RE: Sheffield Gardens Project – Parkland Fee Waiver Request

Comment 19.# - Gina Zwart letter dated 3/10/2025

## Comment 21.# - Karina Tipton email/letter dated 5/9/2025

*RE: Draft Environmental Impact Statement (DEIS) for the Proposed Sheffield Gardens Project*

## MONTGOMERY ORANGE CO AIRPORT, NY US (USW00004789)

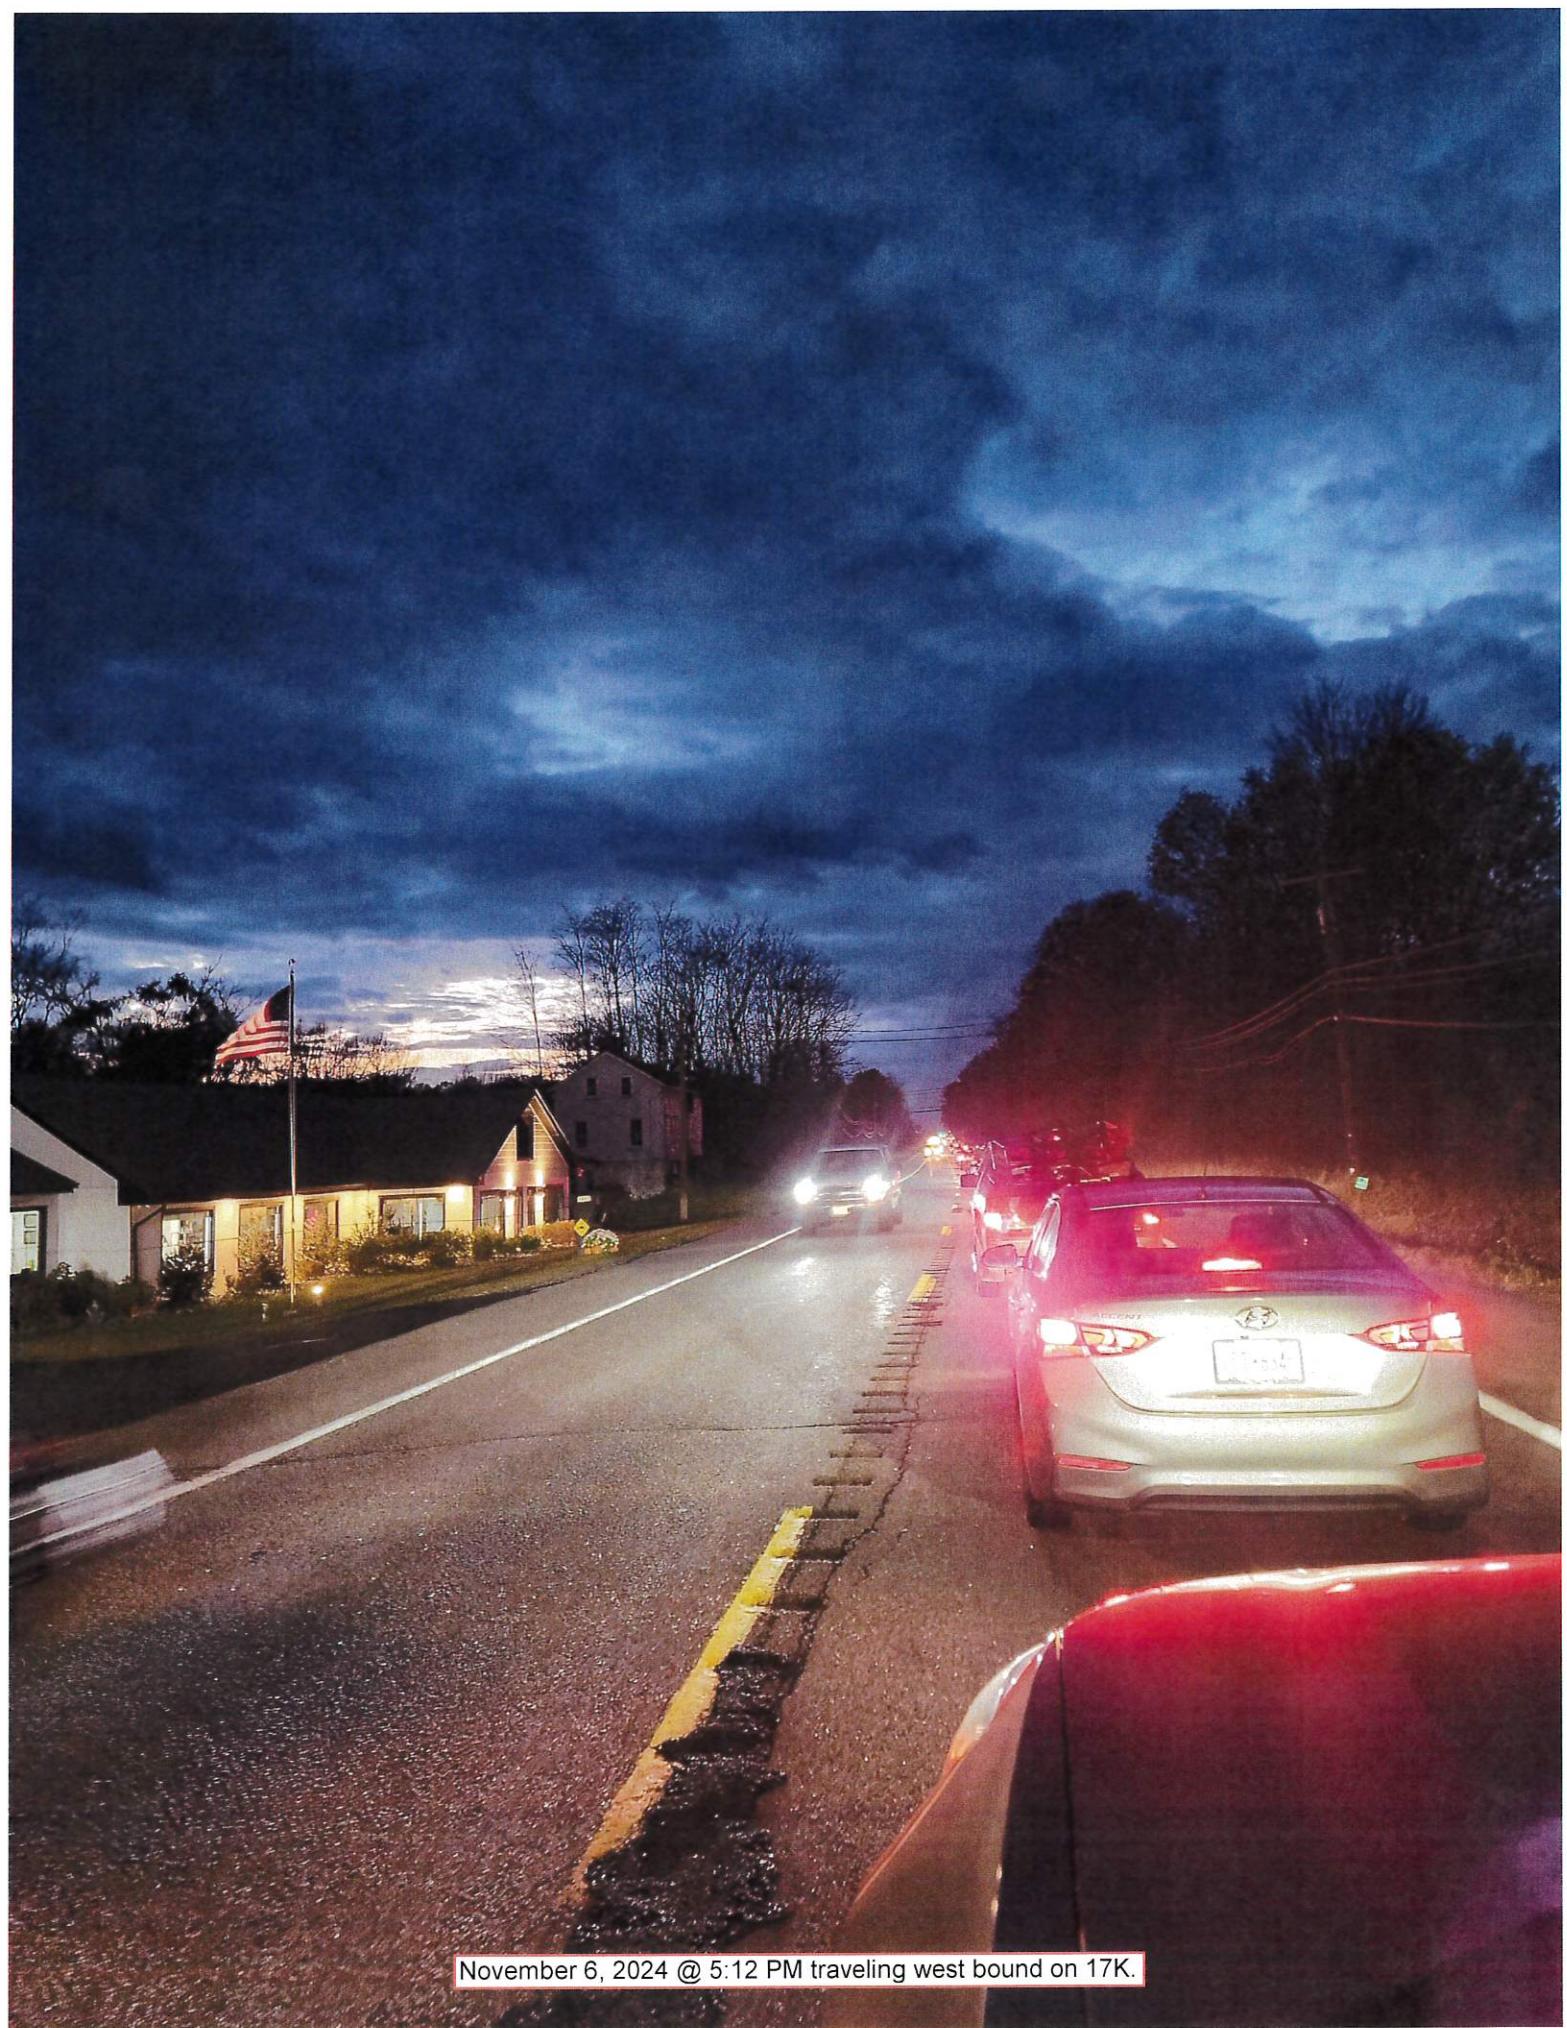
24.1 1) The constant rate pumping tests for these wells were performed after the wettest and warmest winter in decades and cannot be an accurate report of the ground water volume and how it may affect adjoining properties' wells. New tests should be performed after a period of dry weather (similar to the 2024 late Spring and Summer conditions) to get an accurate survey of the worst case scenario. See attached precipitation data from NOAA.

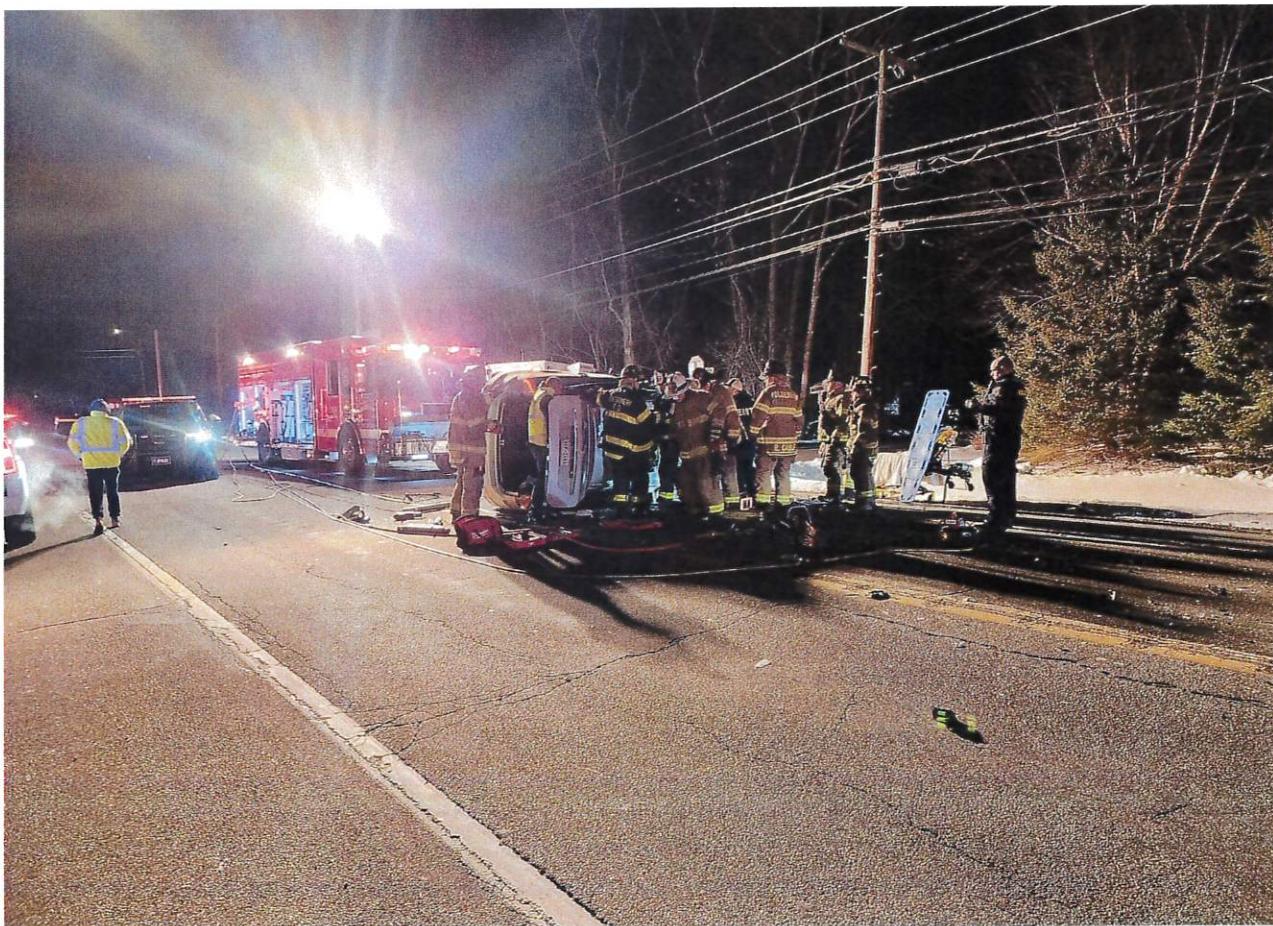
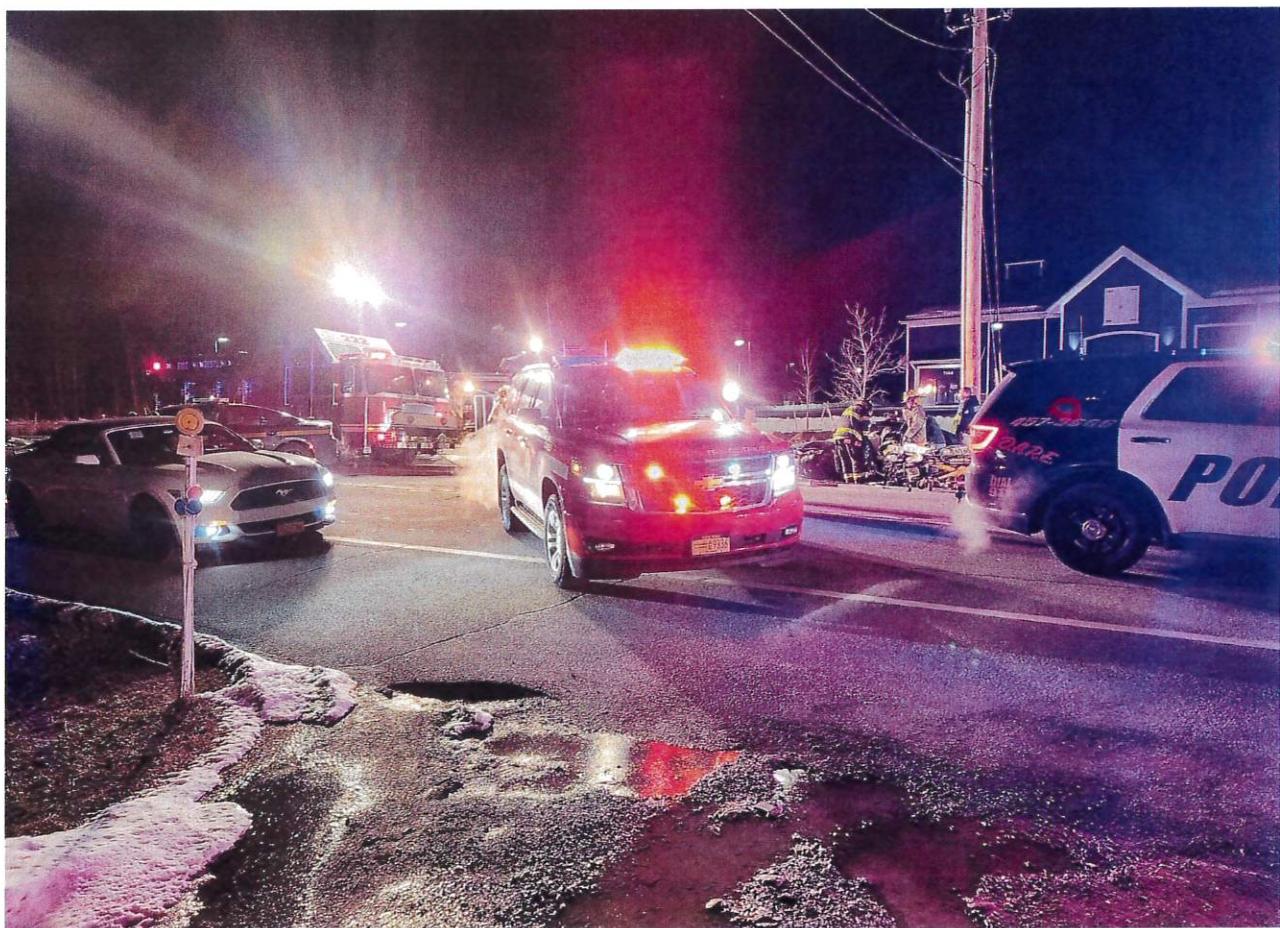
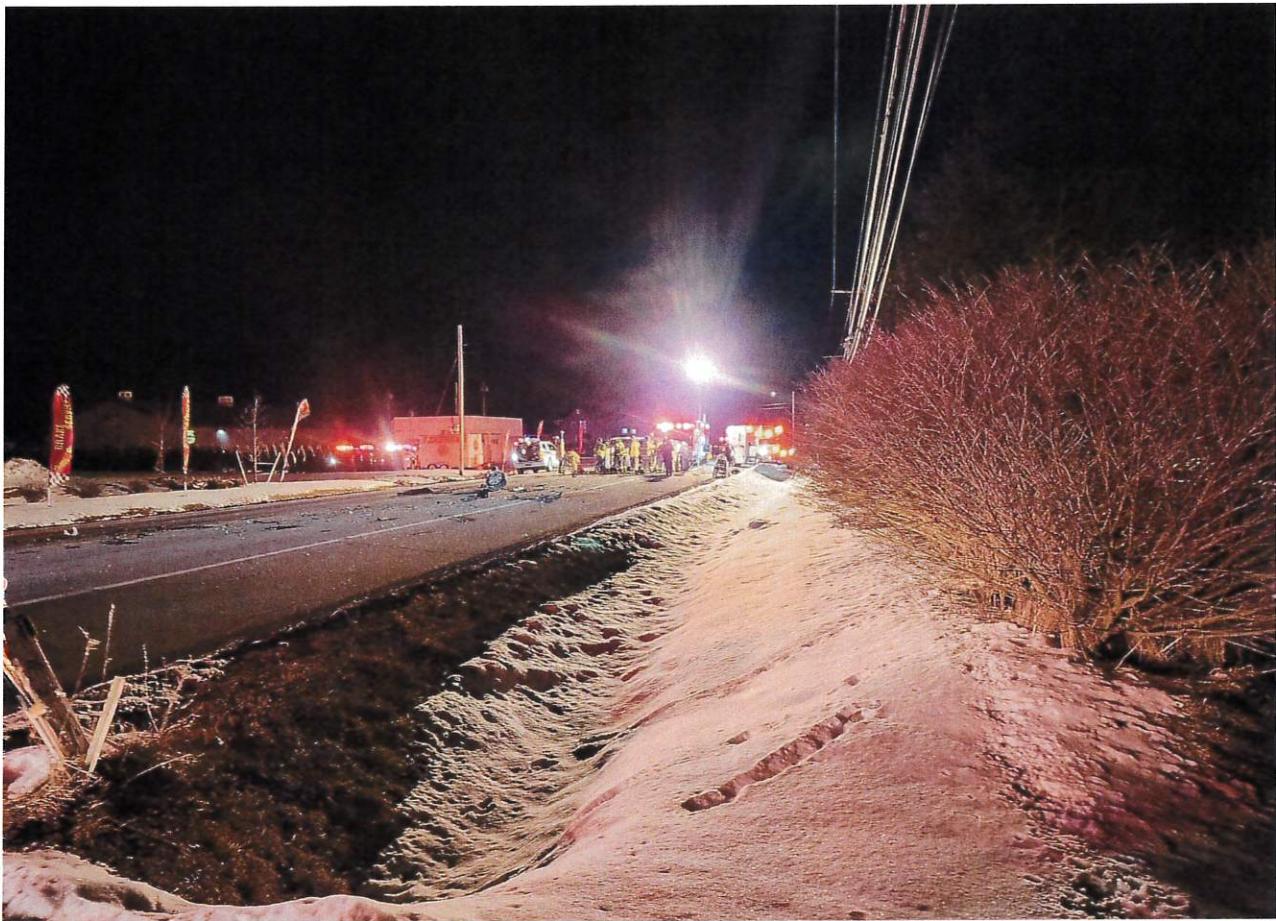
October 2, 2024 @ 5:16 PM traveling west on 17K.

November 6, 2024 @ 5:12 PM traveling west bound on 17K.

Head on collision occurred on February 17, 2024 @ 9:23pm.  
Victims were extricated from vehicles at 10:06pm.
